DLP® Products Advisory for the DLPR410 and DLPR910 Devices

AMD Xilinx stopped production of the XCF16P Configuration PROMs used as the base device for the following TI devices: 2510442-0005, DLPR410YVA, DLPR410AYVA, DLPR410BYVA, DLPR910YVA, DLPR910AYVA. This document details the Texas Instruments product design updates and support.

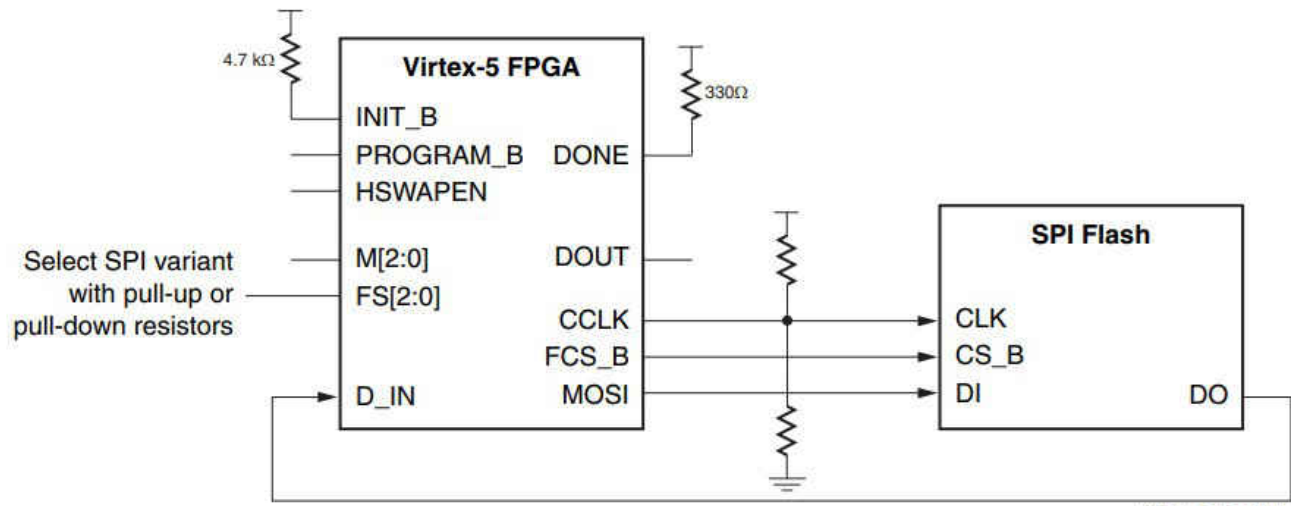
The DLPC910 and DLPC410 Controllers must be connected to SPI Flash using the connections described in the diagram below

SPI Flash Write Protect (WP#) should be pulled high to allow for programming through the Virtex 5 JTAG interface. SPI Flash Reset (RESET#) or Hold (HOLD#) should be pulled high to prevent the SPI Flash from pausing serial communications with the DLPC410 and DLPC910 controllers.

FCS_B = pin AA10 of DLPC910 Controller and DLPC410 Controller

MOSI = pin AA9 of DLPC910 Controller and DLPC410 Controller

CCLK = pin J10 of DLPC910 Controller and DLPC410 Controller

D_IN = pin K11 of DLPC910 Controller and DLPC410 Controller
